Geology and Soils

APPENDIX F-1

GeoLabs Report Sept 14, 2018

SUBJECT: Update Geotechnical Report,
Tentative Tract Map 5658-A, North Canyon Ranch,
City of Simi Valley, California

G1

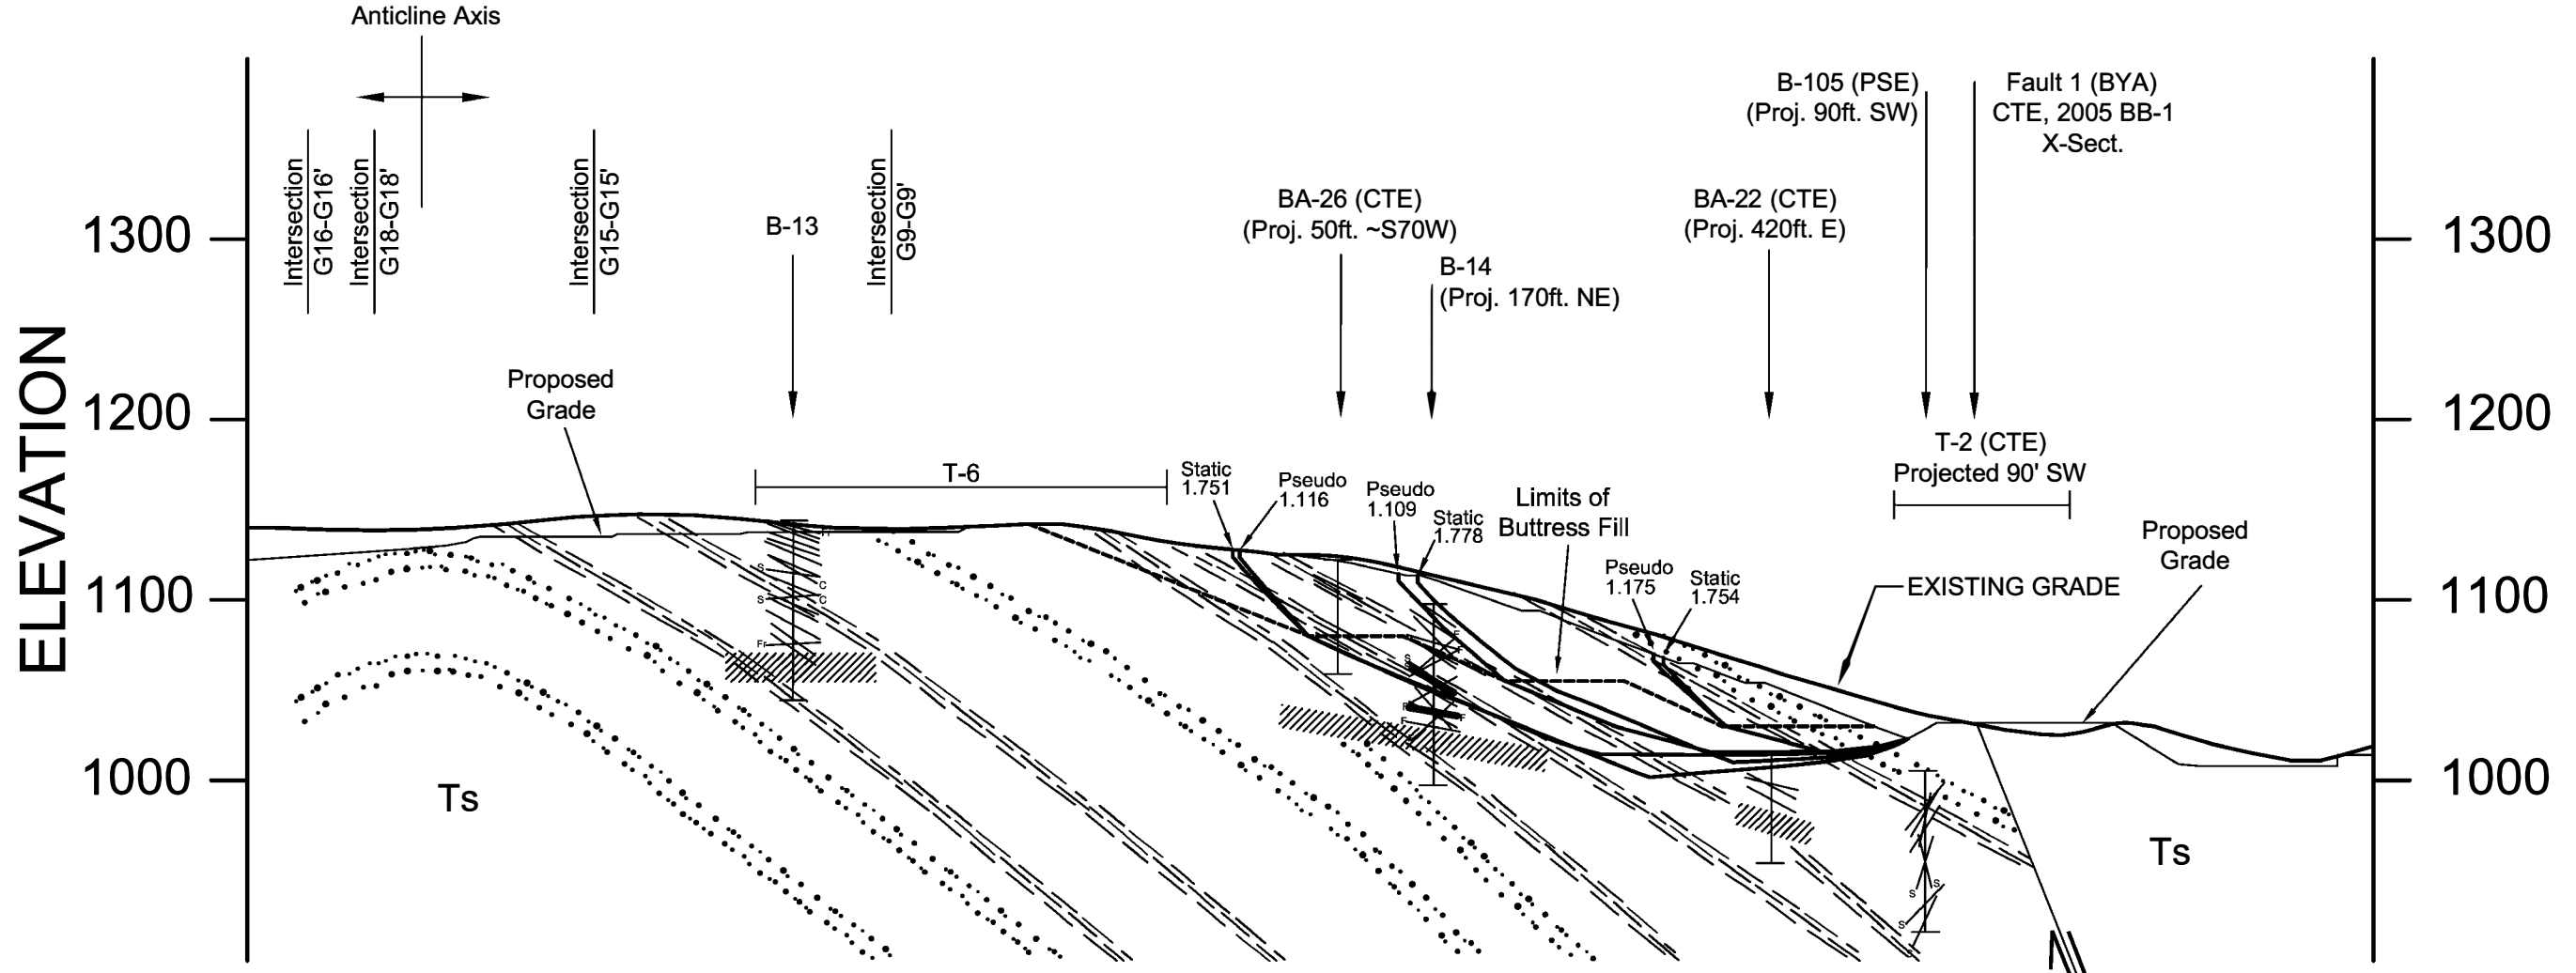
Proposed contours were provided for the central ridge buttress area illustrated in cross section G1. This configuration requires buttressing to mitigate the presence of shallow dipping fine-grained beds within the bedrock. This new buttress expands the limits of grading (see Plate 1.2). The buttress design is discussed below in the "SLOPE STABILITY" section of this report.

Slope stability analyses considering proposed grades with along-bedding failures through these layers obtained inadequate factors of safety for both static and pseudostatic conditions. A buttress was designed to partially remove these layers such that adequate factors of safety may be obtained. The upper layer should be removed to an elevation of 1030 feet, the middle layer to an elevation of 1055 feet, and the lower layer to an elevation of 1080 feet. The removal is illustrated on the cross section (see Plate 2.1) and in the output from the slope stability analyses (see Appendix A). This buttress provides the slope adequate static and pseudostatic factors of safety considering along-bedding failures through each of the fine-grained layers as indicated in the table below.

For the temporary condition exposed during construction, the portion of the backcut between the top of slope and the removal of the lower clay bed was found to be the most critical. A 2.5:1 (horizontal:vertical) gradient for this portion of the slope was found to provide an adequate factor of safety for the temporary condition of 1.417. Rotational analyses of the buttress configuration were not performed as a taller buttress was evaluated in a previous report with identical fill strengths and found to have adequate factors of safety (see GWV, 2007).

This slope and buttress configuration expands the limits of grading approximately 150 feet along the ridgeline. The anticipated limits of grading of slope stabilization have been revised on the enclosed Geologic Map (see Plate 1.2) to reflect the current buttress design.

G24

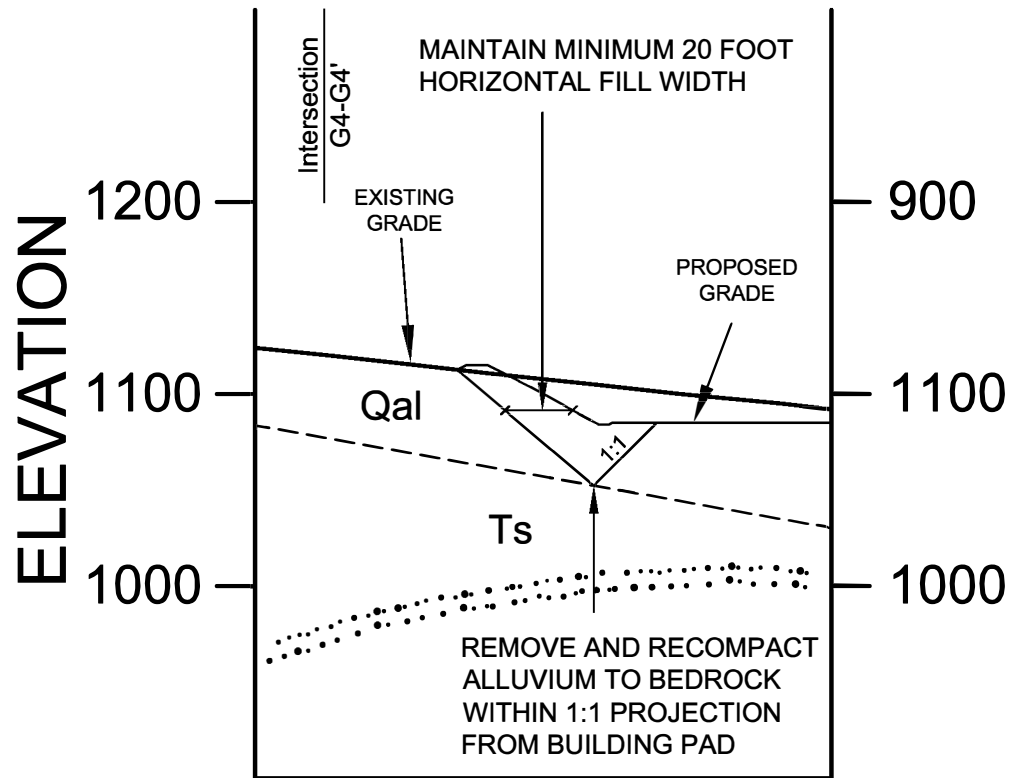
Cross section G24-G24' (see Plate 2.24) was drawn through the proposed cut slope at the north end of the central canyon behind Lots 52 to 55. This slope is anticipated to expose alluvium in the slope face and should be rebuilt as a typical stability fill per the enclosed detail (see Plate B.1). Removals of alluvium, landslide debris, or other unsuitable materials should be performed within a 1:1 projection from the edge of the building pads as illustrated in the cross section.

A1'

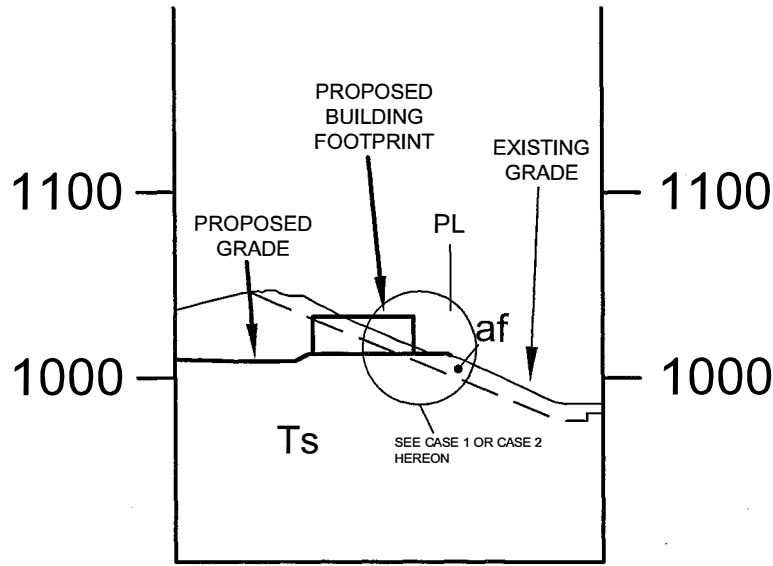
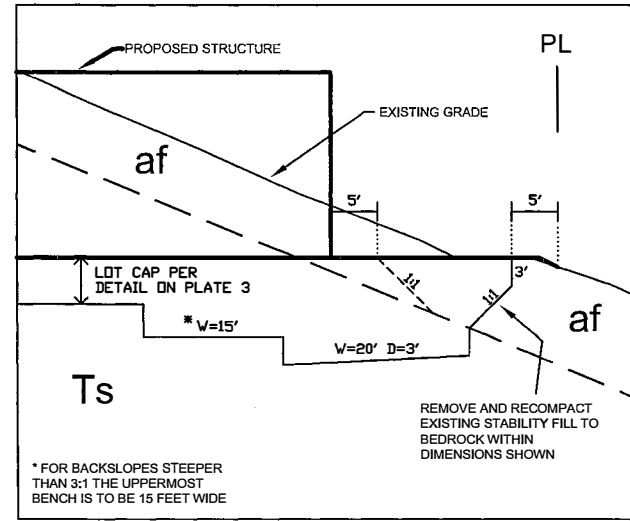
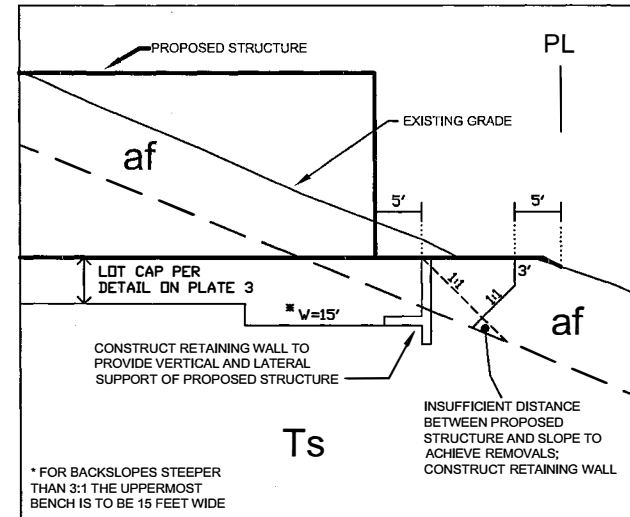
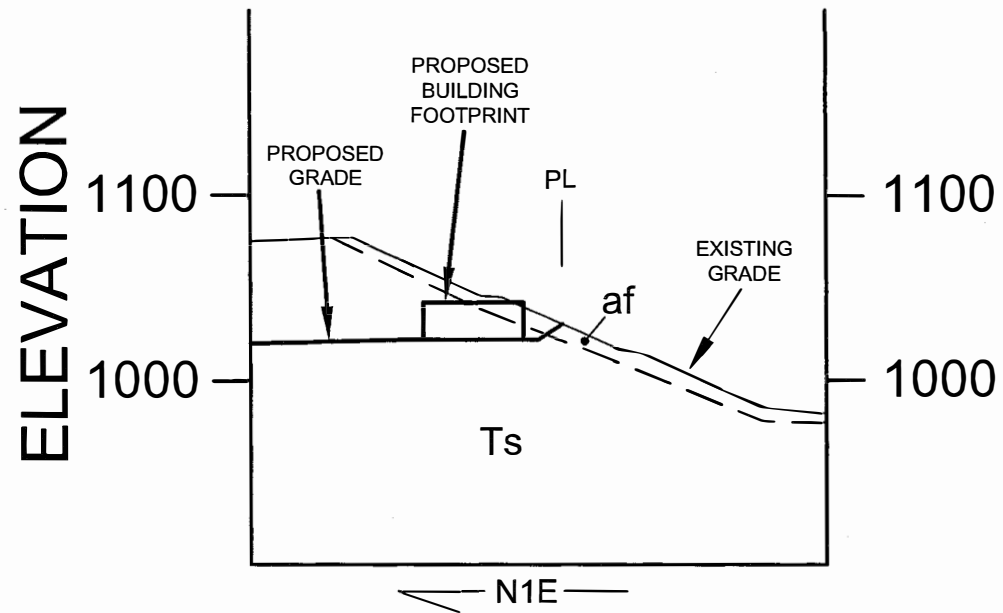
- The consultant states that "portions" of the southerly descending slope were rebuilt as a stability fill to *"mitigate stability concerns due to a clay seam (CTE 2004)"*. Based on the map, it appears that the entire slope is constructed of artificial fill. The consultant should provide a more in-depth discussion of the geotechnical conditions that required stabilization and the limits of the stability fill.

- The consultant presents a discussion of the stability fill configuration presented by CTE on Cross Section CC-CC' and concludes that the configuration depicted is not acceptable and should be verified during the grading plan stage of development. The reviewers concur with the consultant's assessment regarding the fill configuration. The reviewers are also concerned that the cross section as presented by CTE does not reflect the shallowing of dip in the axial region of the syncline observed nearby. The recommended exploration should be sufficient not only to assess the fill configuration; but further to verify that the dip inclinations remain steeper than the slope. Should dip inclinations shallower than the slope be encountered, exploration should continue to sufficient depth to verify that low-strength lithologies are not present within vertical limits that could influence the slope stability analysis.

We have developed two cross sections, A1 and A2 (see Plates 2.1 and 2.2), to illustrate simple methods available to address the Slope Issue along the south side of the apartment site. The section locations are indicated on the attached Geologic Map, Plate 1. They consider a case where portions of

the stability fill are anticipated to remain beneath the planned pad (A1), and a case where it is not (A2). Mitigation via removal and recompaction, with and without additional support from a buried retaining wall, are illustrated in the case where mitigation is required, A1. This represents but one concept to mitigate impacts from the Slope Issue for the purpose of illustrating project feasibility without offsite work; other viable concepts may be considered for value engineering purposes.
